ADA Curb Ramp New Construction Inspection Form (Perpendicular)

Nw 285

24952.54

Nw mays

PERPENDICULAR RAMP (PR)

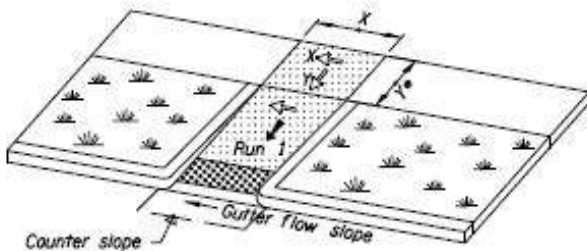
IITD RR1 fail
